DATE: July 11, 2025
RE: **Clarendon Hill Thoroughfares Revision Narrative**
FROM: Kendra Halliwell and Tim Synan, ICON Architecture

The total redevelopment of Somerville Housing Authority's Clarendon Hill will include up to 591 new and replacement housing units, common space, public roadways and central park, and the improvement of the intersection at Powderhouse and Alewife Brook Parkway.

CLARENDON HILL
SOMERVILLE, MASSACHUSETTS

C-107

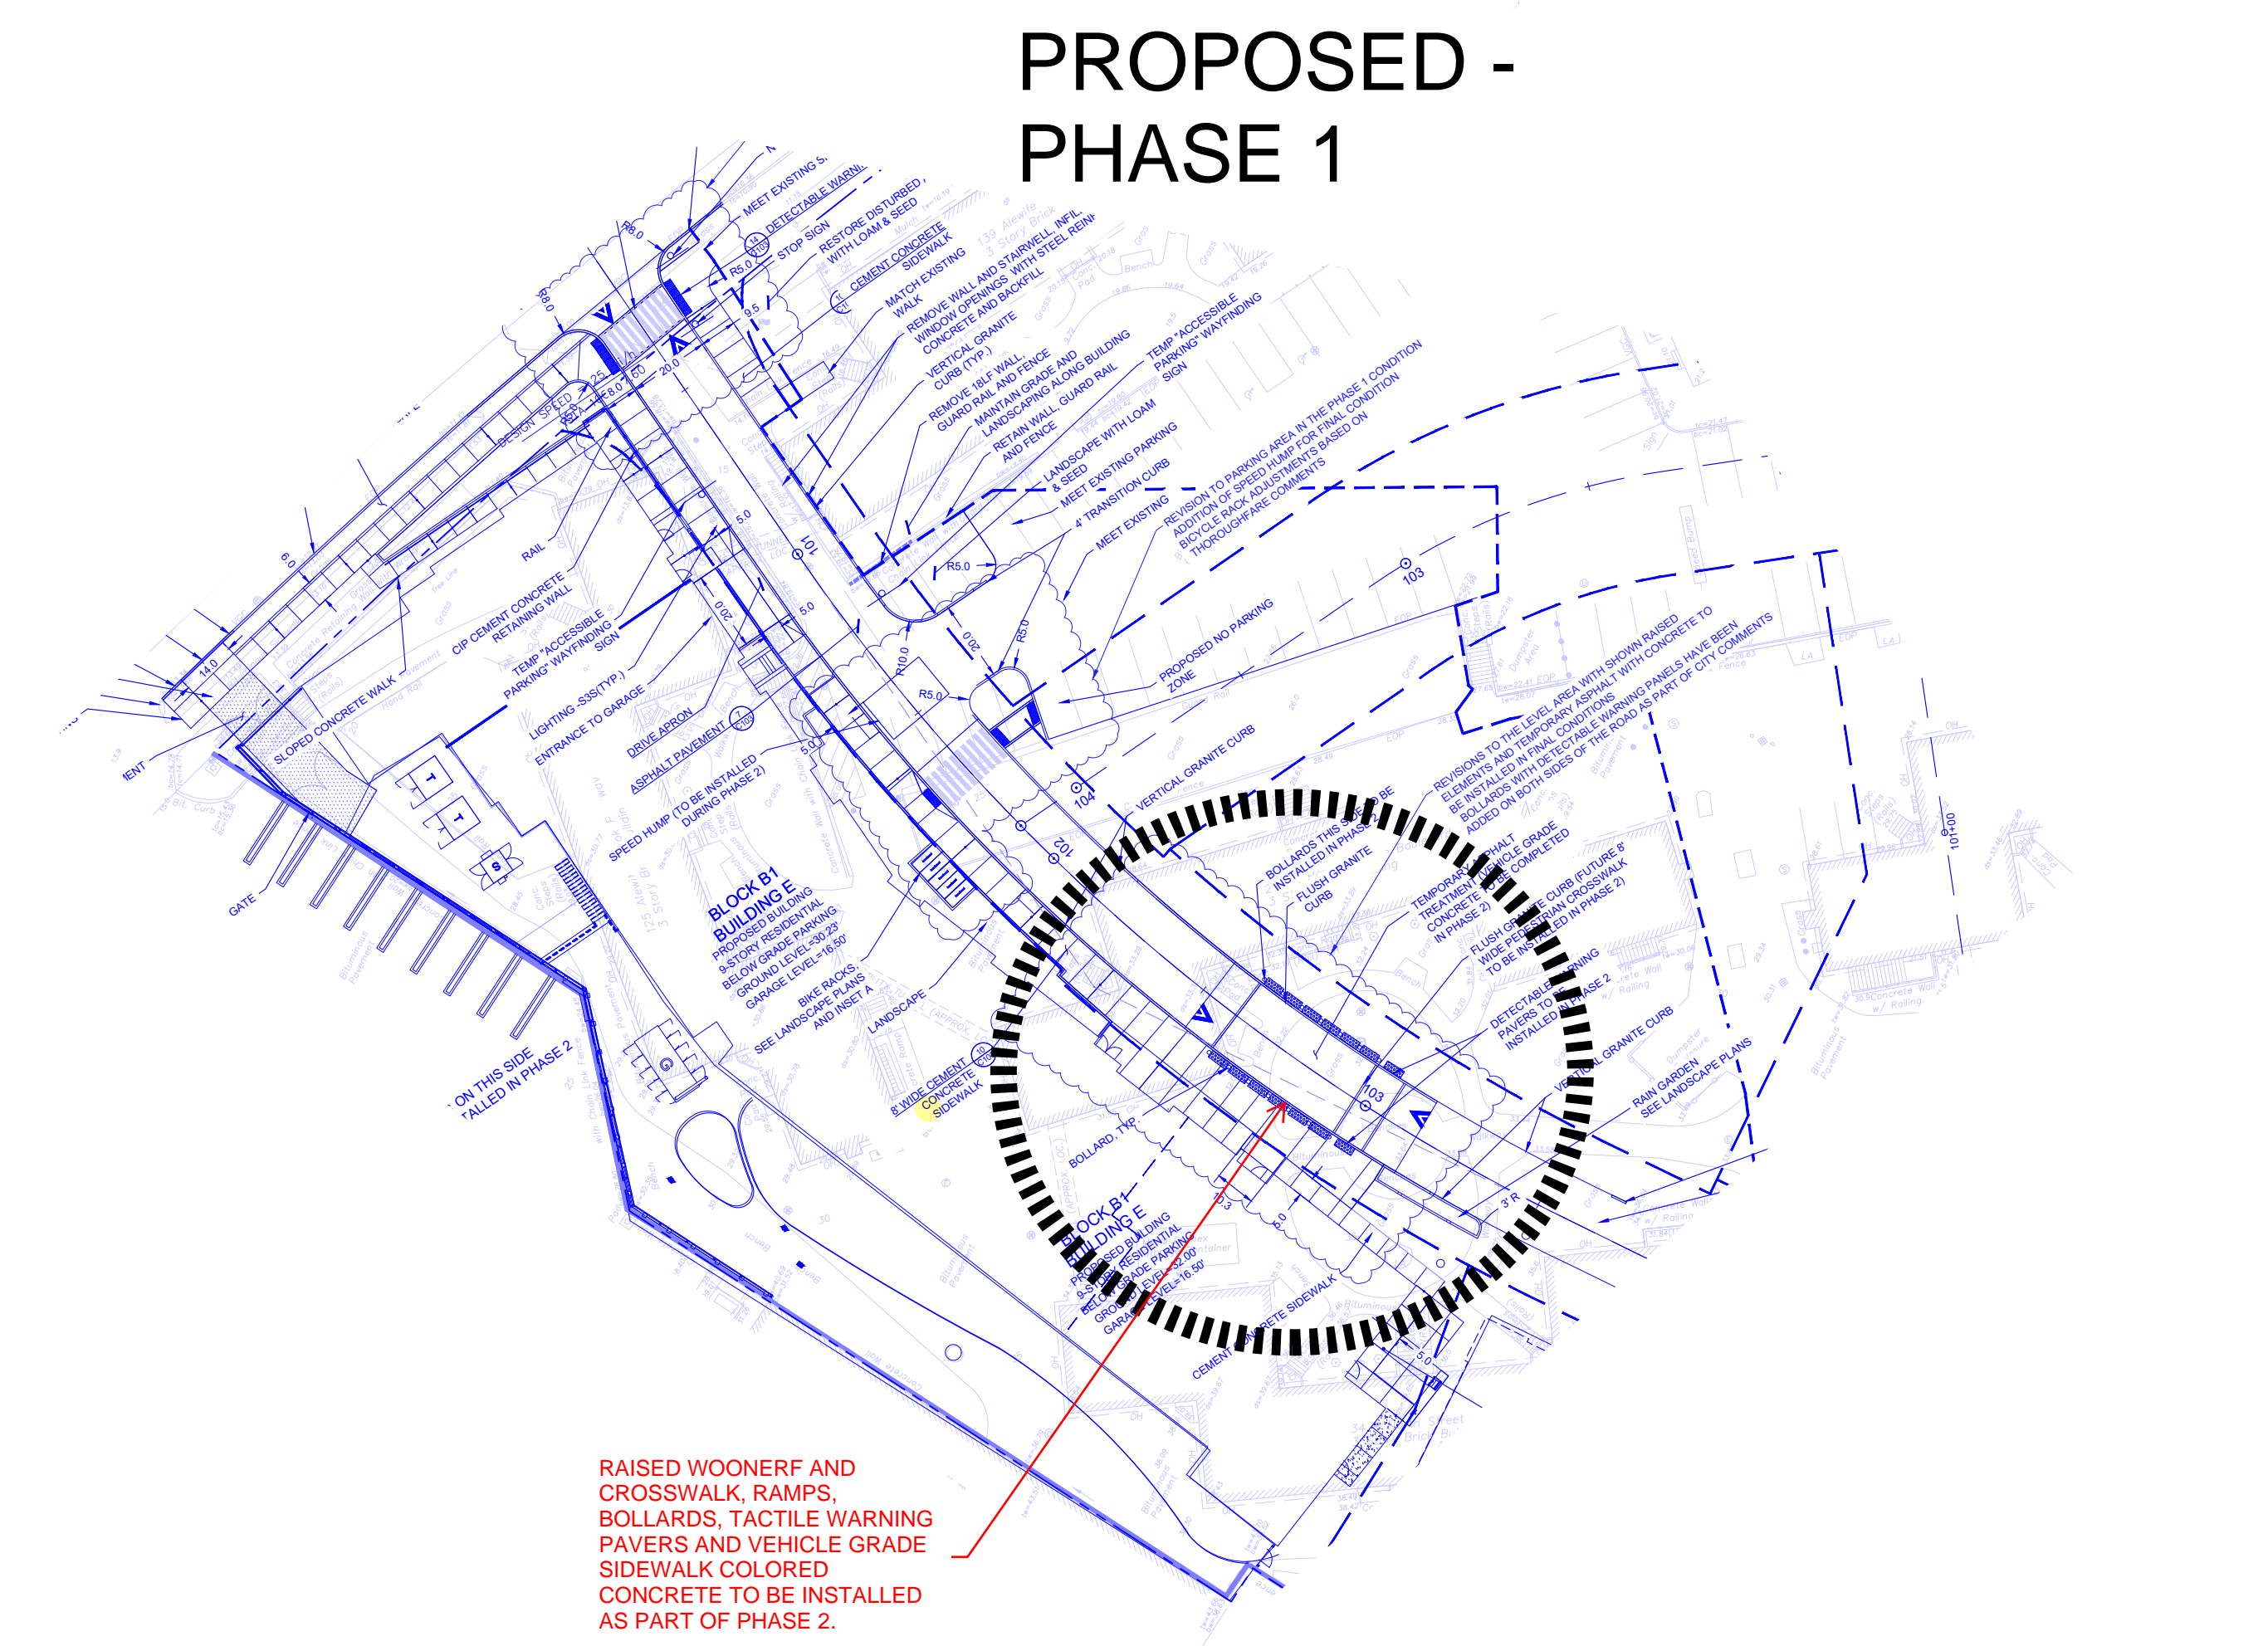
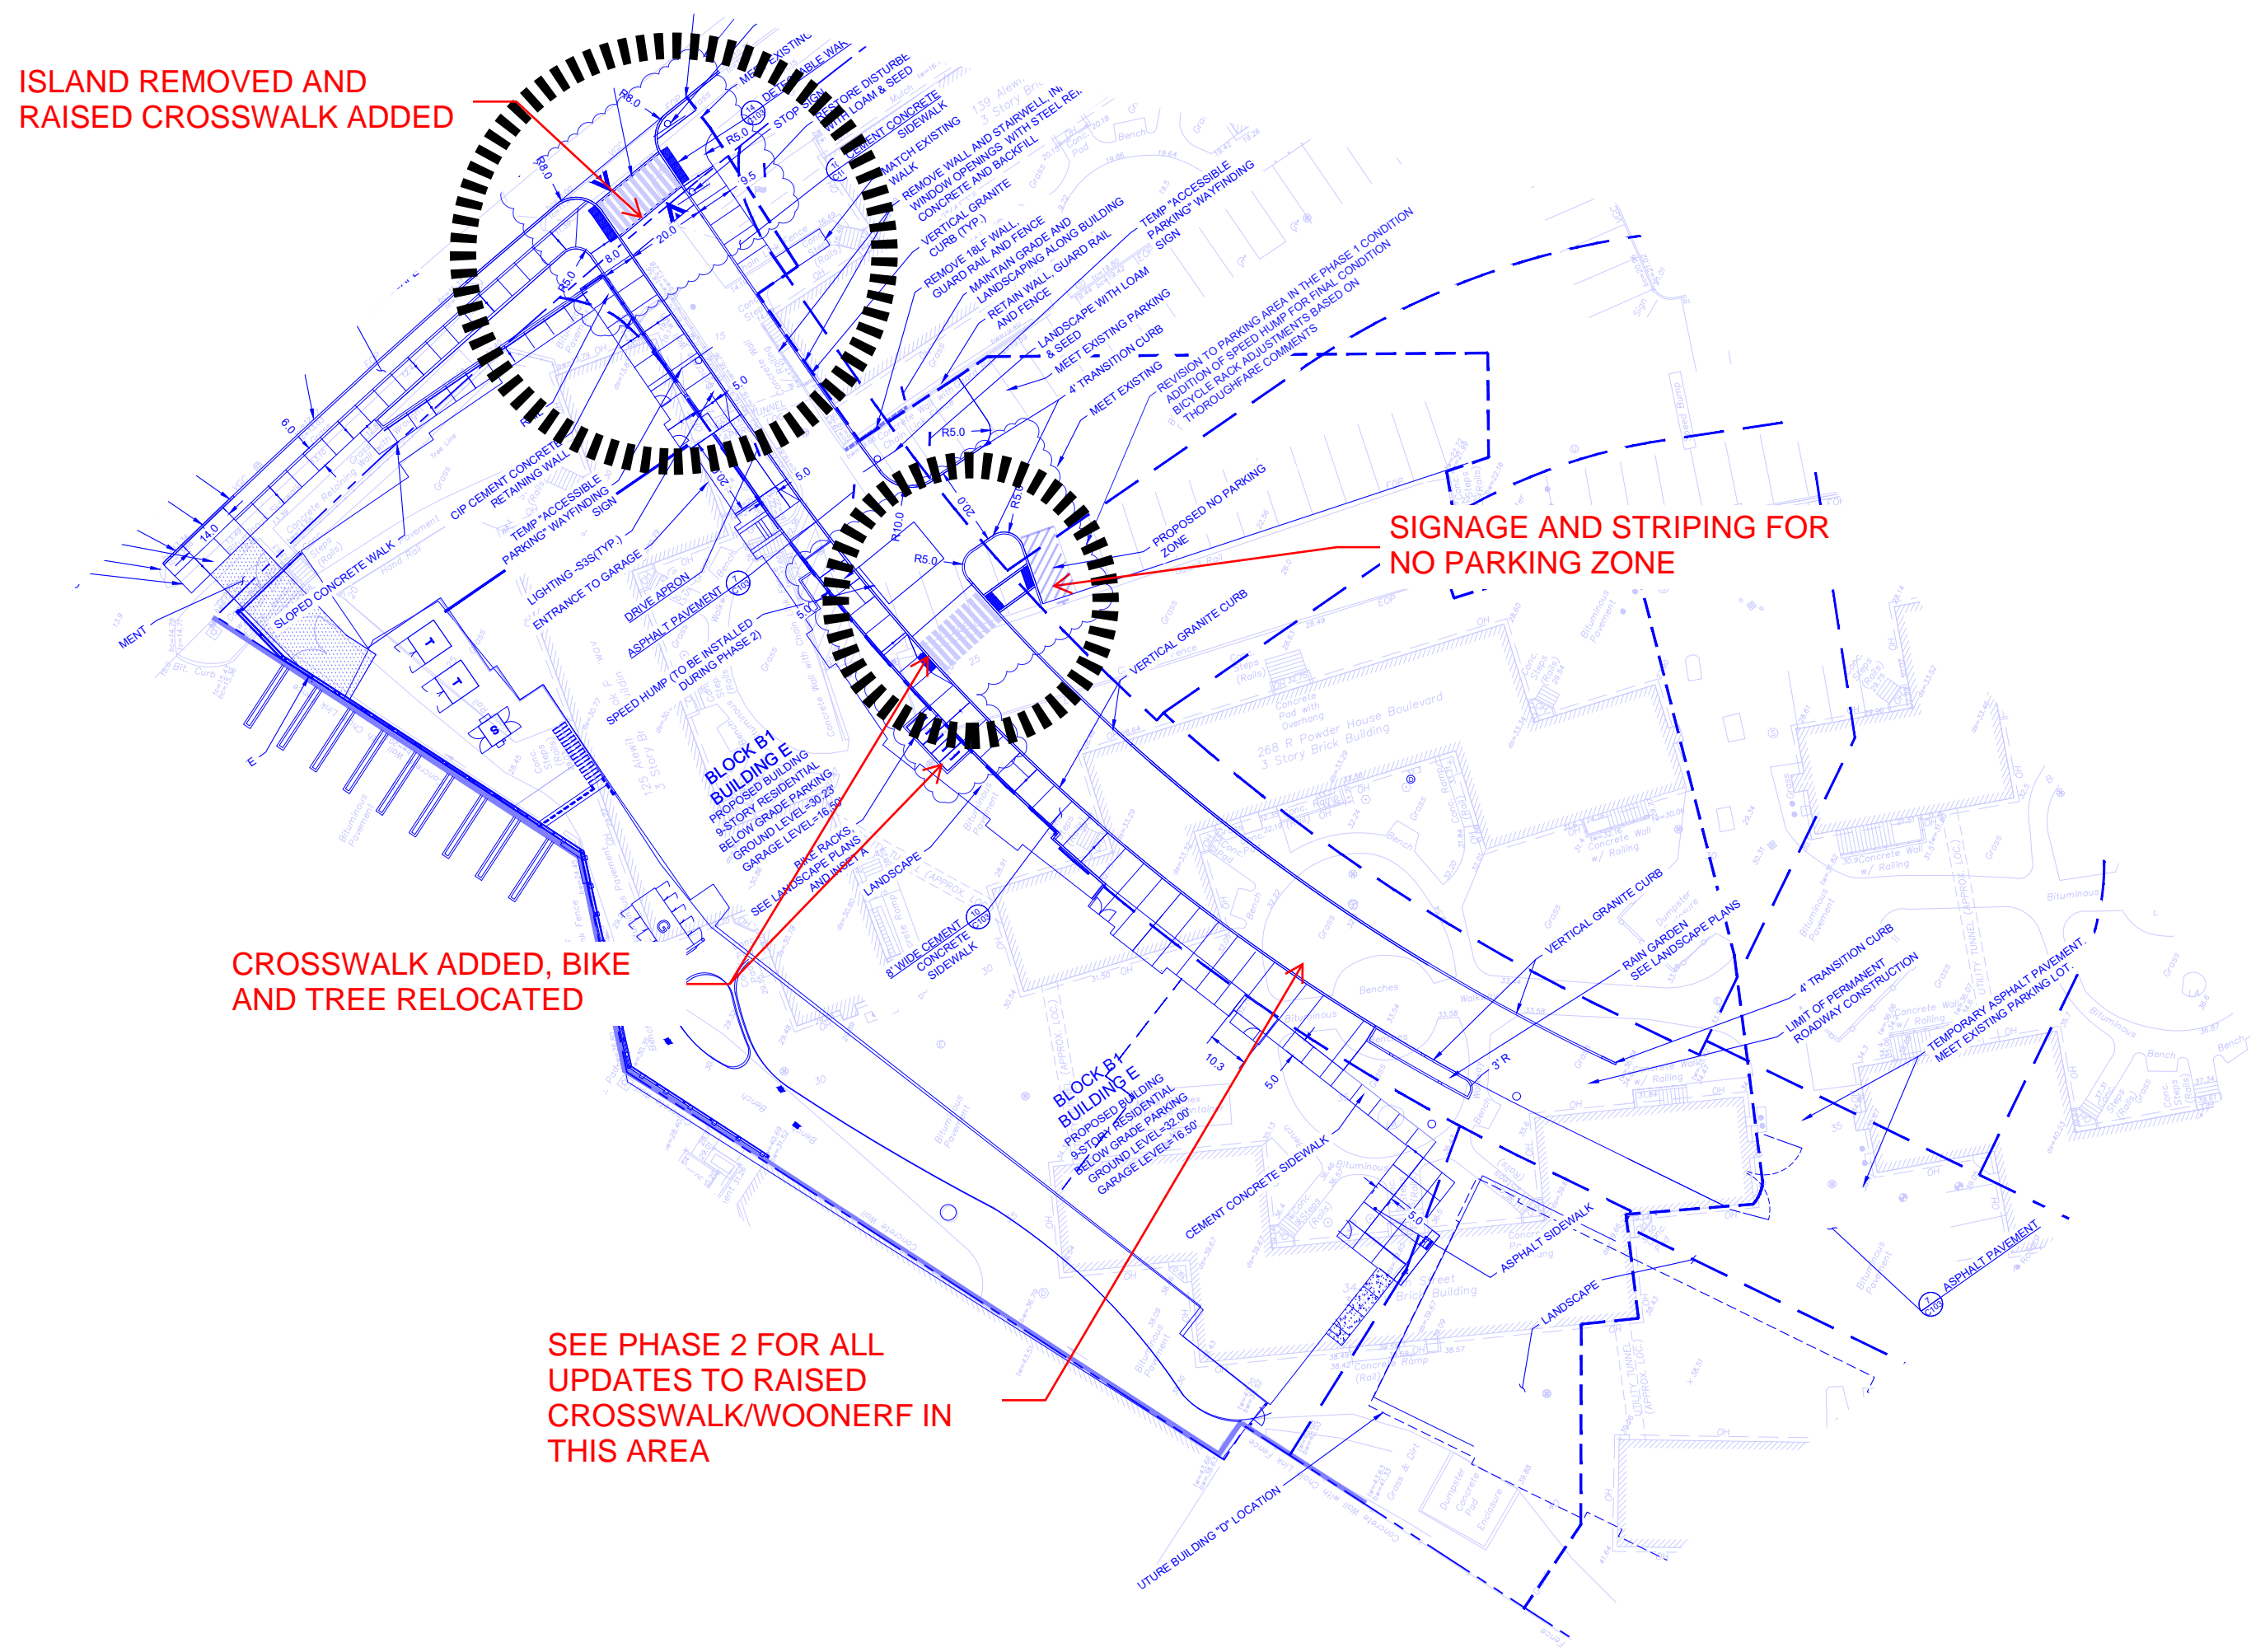
- Alewife Brook Parkway at Stephenson Aman Street, added raised crosswalk added and removed island.
- Typical corner crossings will be city standard thermoplastic striped paint, and the woonerf paving will be vehicle-grade concrete paving (phase 2).
- Bike racks are relocated from furnishing zone onto private property.

- Street Tree Pit Relocation: Adjacent to the woonerf (phase 2) a tree has been relocated and bike rack shifted, to avoid conflict with curb ramp.
 - Planting area: Removed from park side of crossing, and added planting edging near Building E entrance.

- Rain garden area: Combined with phase 2 rain garden in civic space.
4. Signage/stripping:
- No parking zone to be provided in the surface parking lot adjacent to the crosswalk. There should be signs and pavement striping defining no parking in this area.
